Origination Form
Proposed Revisions to a Standard Plans Index

| Originator: | Stepp, Richard | Index Number: | 102-110 |
| E-mail: | richard.stepp@dot.state.fl.us | Index Title: | Type K Temporary Concrete Barrier System |

To accommodate newer Standard Plans options, "Single-Slope" traffic railing and concrete barrier shapes are being added as permanent barrier connection options throughout Index 102-110. Also, per a revision request from the State Materials Office, the word "fabric" is being removed from "geotextile" callouts.

For **Single-Slope, F-Shape, ~~FOR F~~ AND NEW JERSEY SHAPE TRAFFIC RAILINGS AND 8' & 14' TRAFFIC RAILING / NOISE WALLS (Concrete Barrier Similar)**

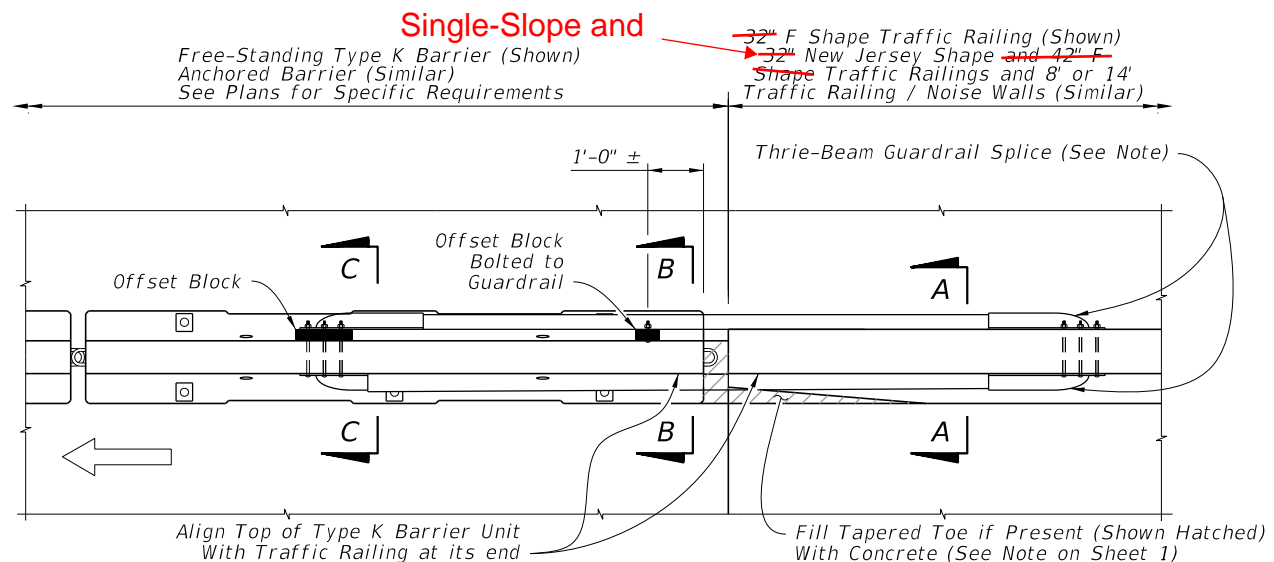
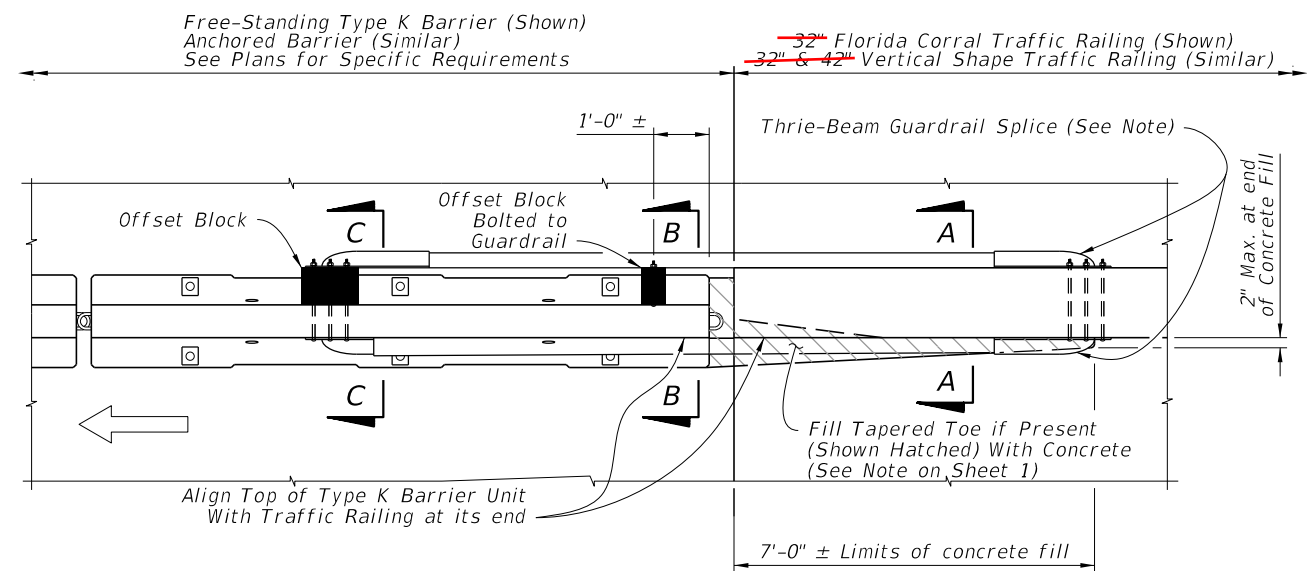
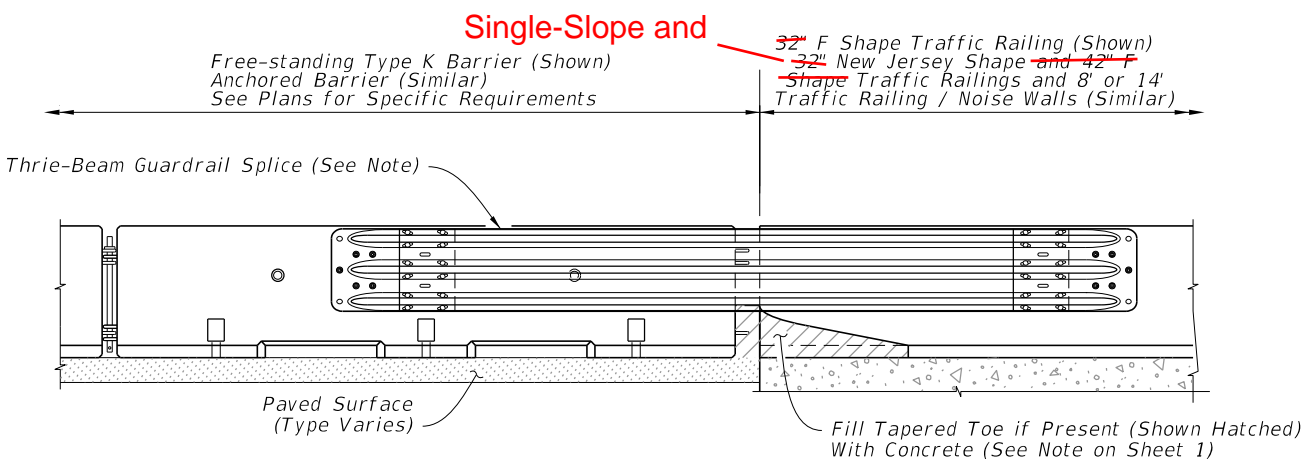
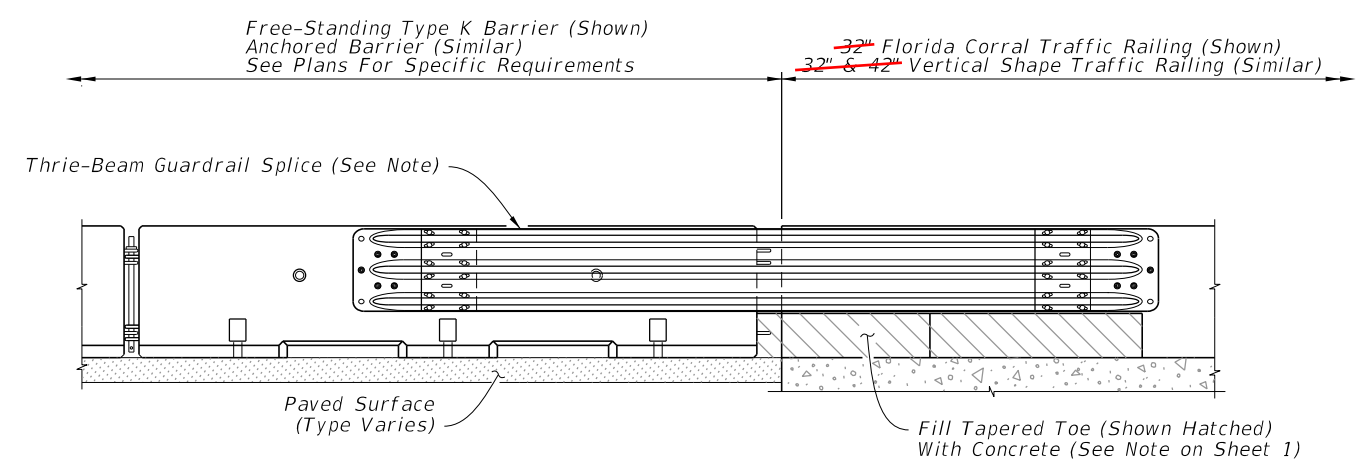
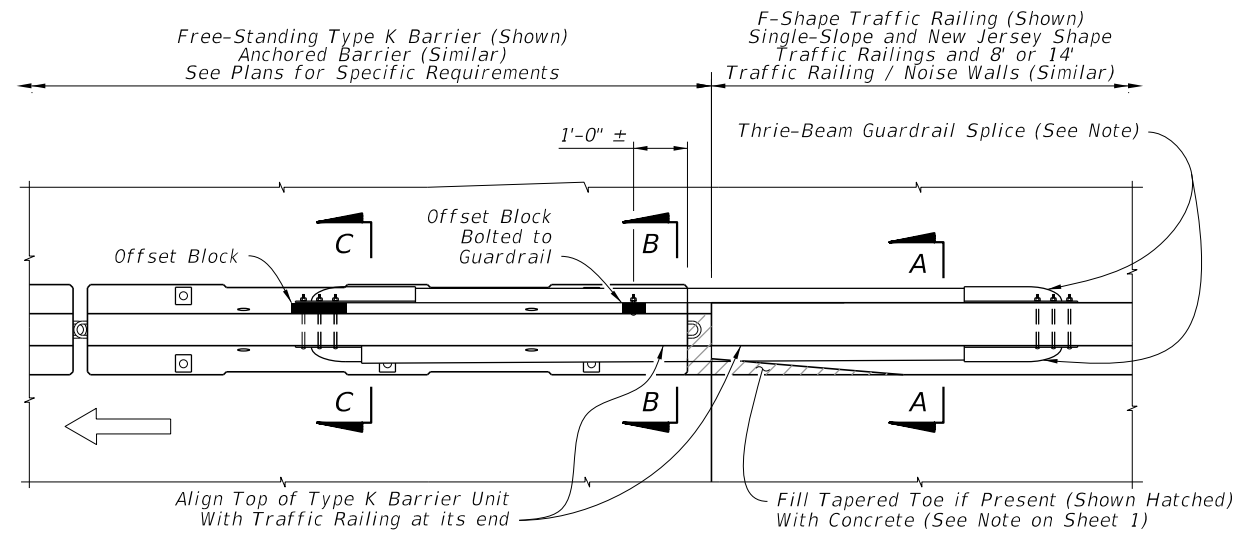
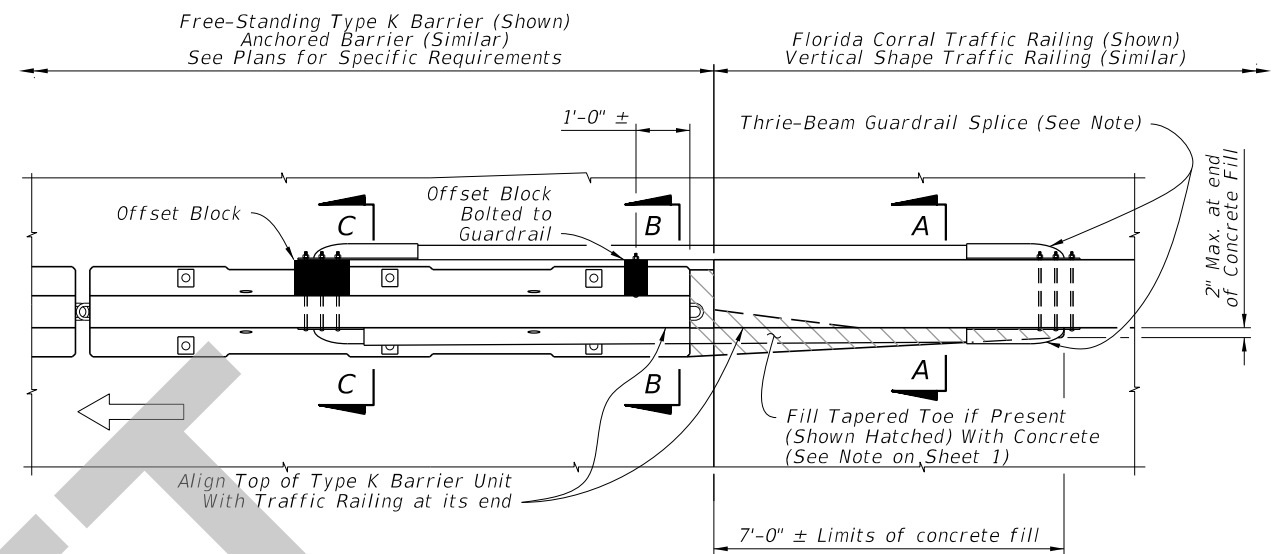
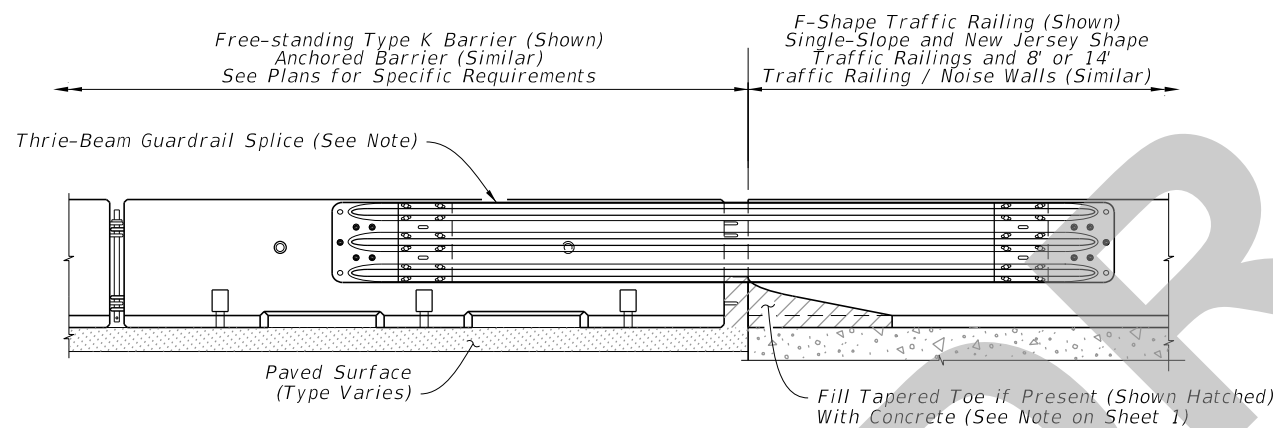
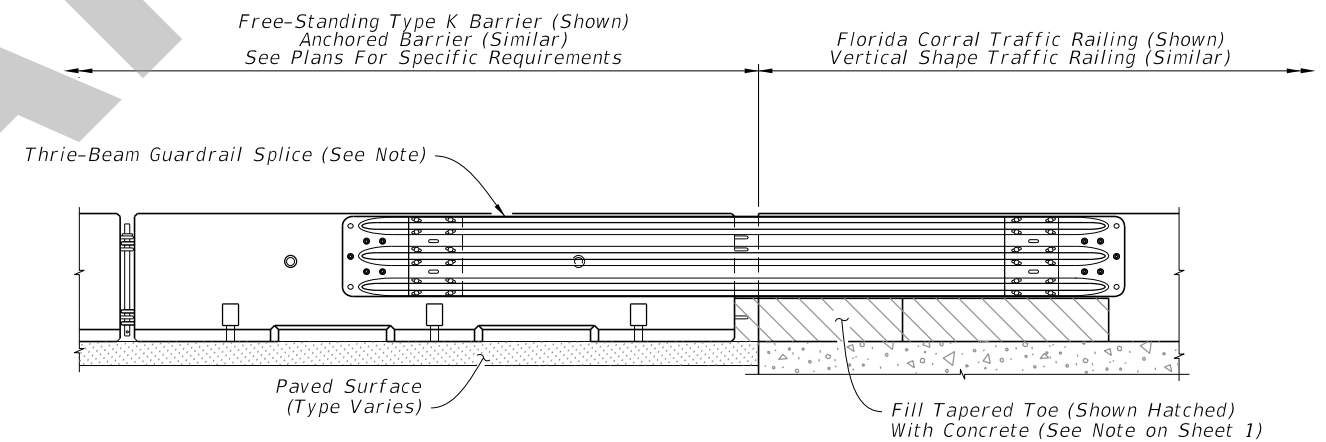
Sheets 7-10: Revised detail labels to simplify and include "Single-Slope" Traffic Railings and Concrete Barriers where applicable

TRAILING END SPLICE DETAIL
FOR SINGLE-SLOPE, F-SHAPE, AND NEW JERSEY SHAPE TRAFFIC RAILINGS AND 8' & 14'
TRAFFIC RAILING / NOISE WALLS (CONCRETE BARRIER SIMILAR)

TRAILING END SPLICE DETAIL
For F-Shape FOR 32" F AND NEW JERSEY SHAPE TRAFFIC RAILINGS WITH RAILING TRANSITION AND END POST

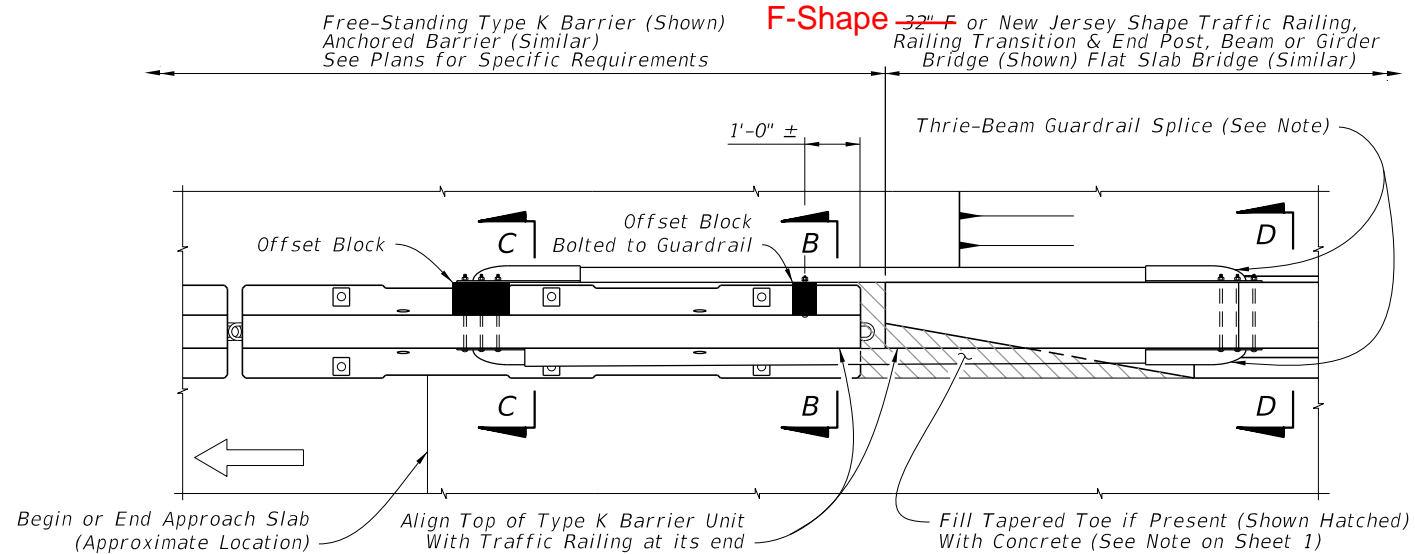
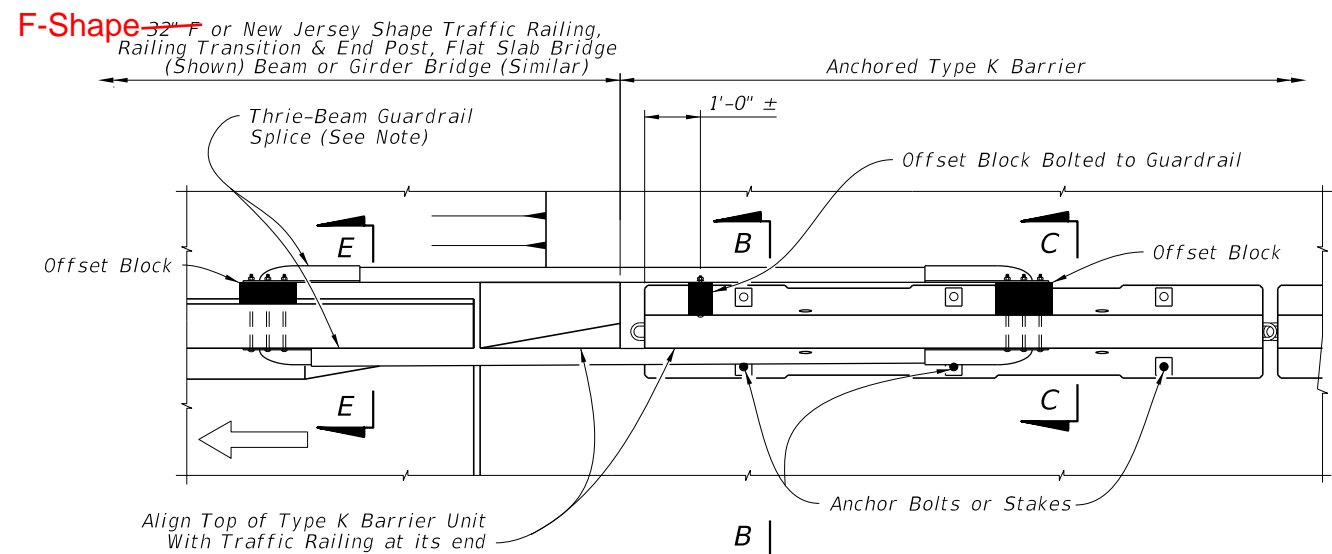
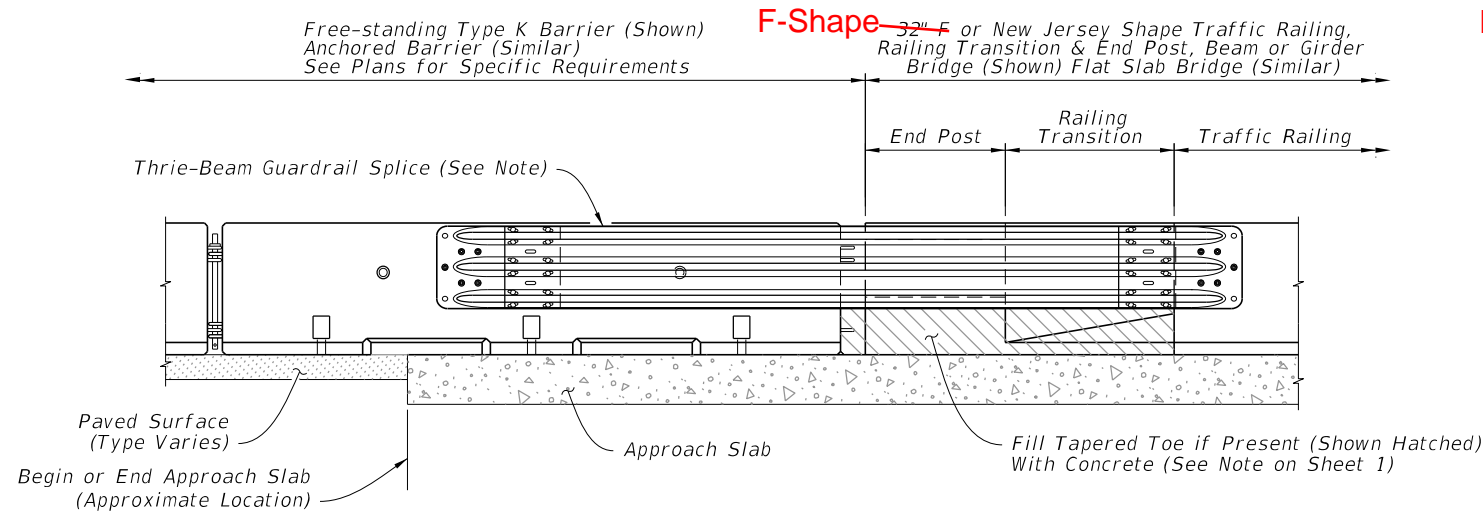
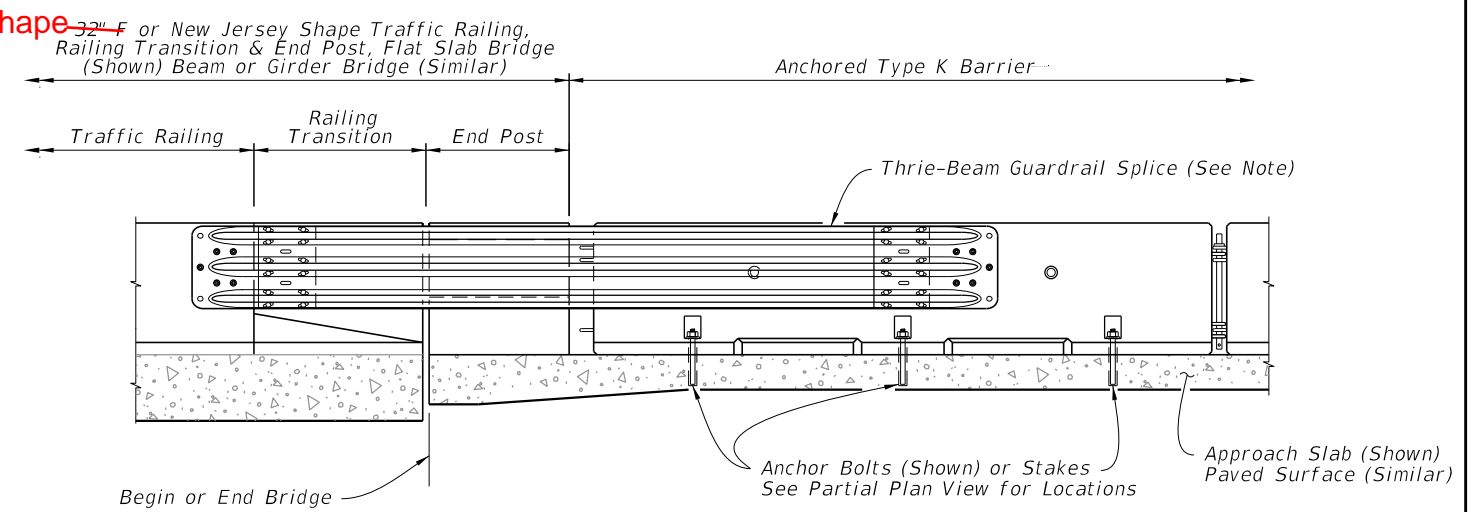
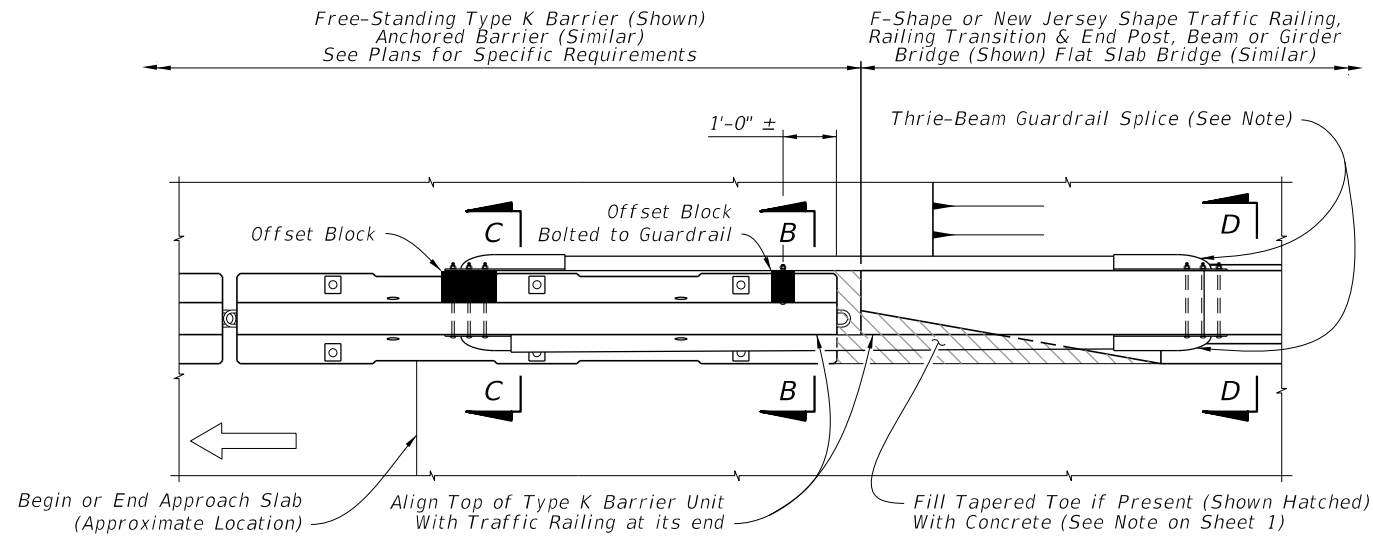
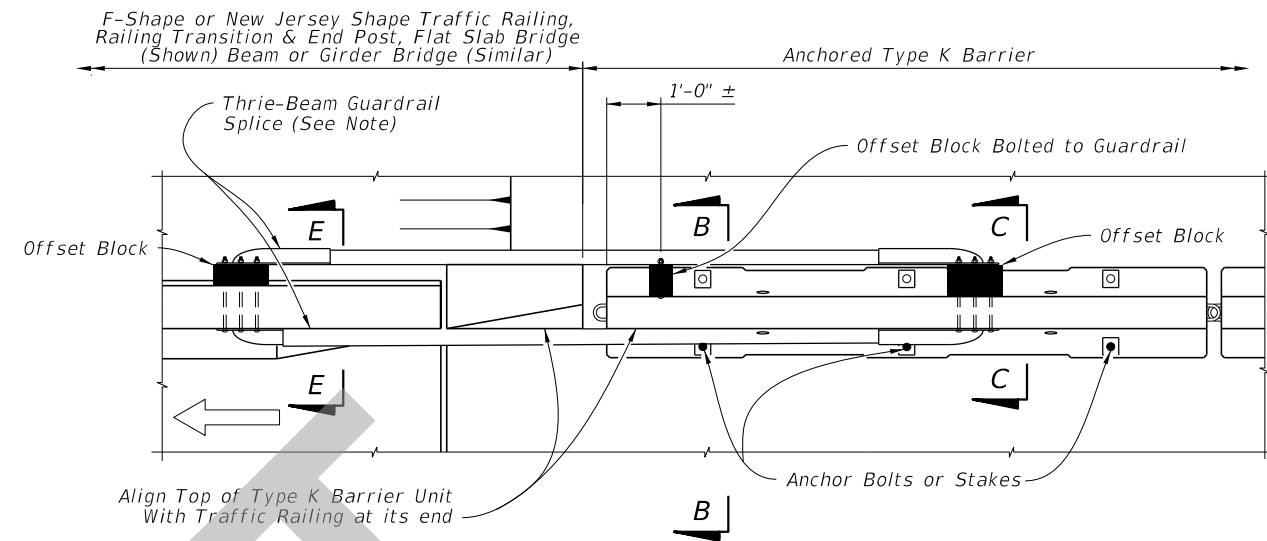
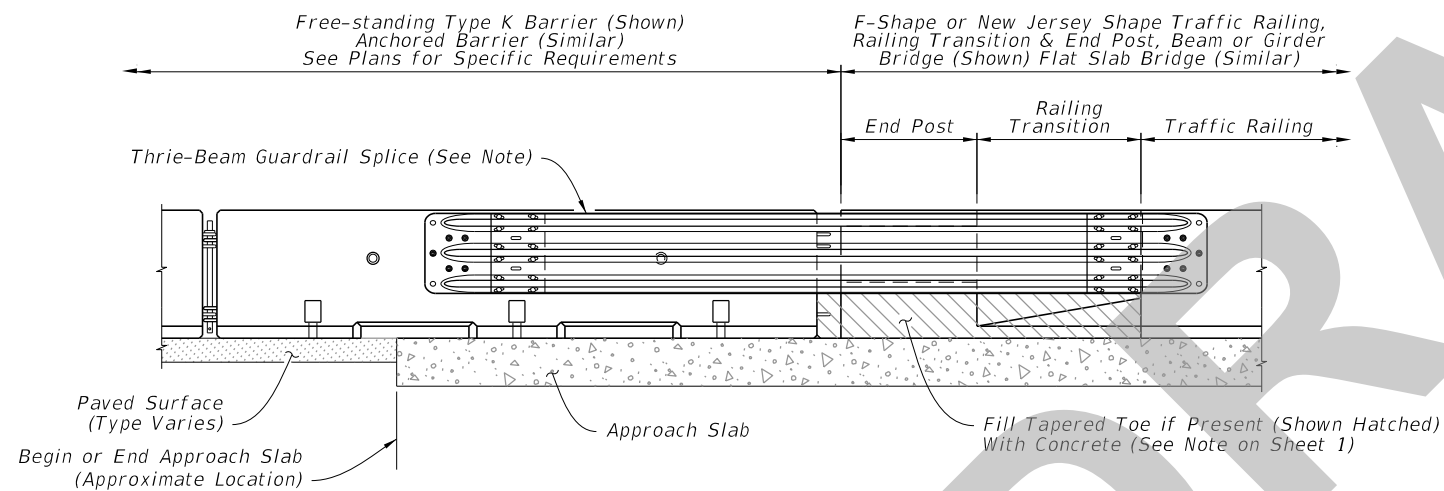
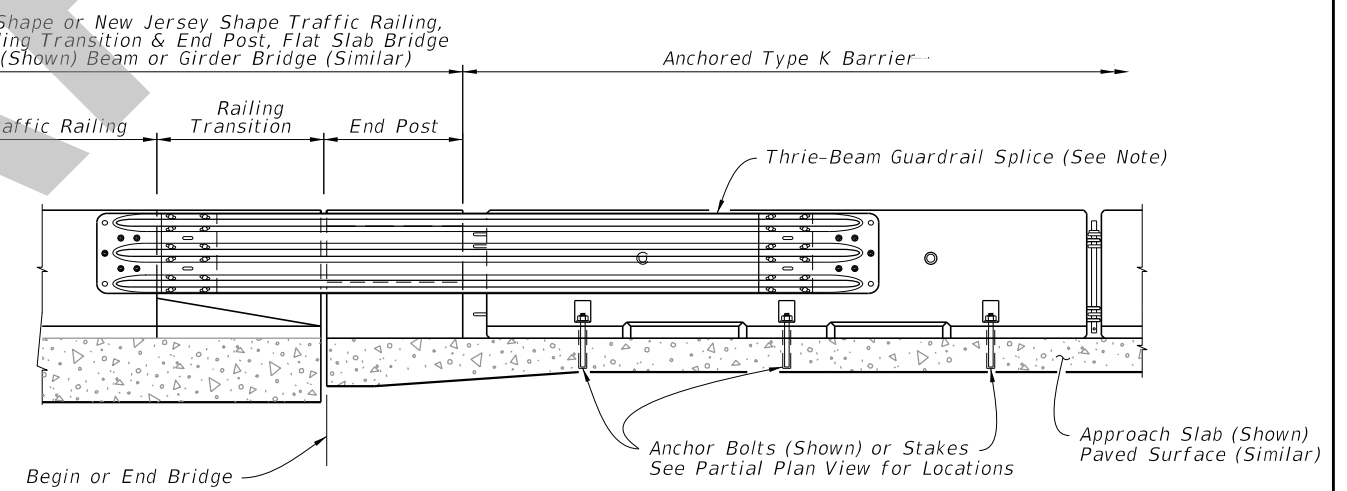
APPROACH TRANSITION SPLICE DETAIL
For F-Shape FOR 32" F AND NEW JERSEY SHAPE TRAFFIC RAILINGS WITH RAILING TRANSITION AND END POST

**TRAILING END SPLICE DETAIL
FOR F-SHAPE AND NEW JERSEY SHAPE TRAFFIC RAILINGS
WITH RAILING TRANSITION AND END POST**

**APPROACH TRANSITION SPLICE DETAIL
FOR F-SHAPE AND NEW JERSEY SHAPE TRAFFIC RAILINGS
WITH RAILING TRANSITION AND END POST**
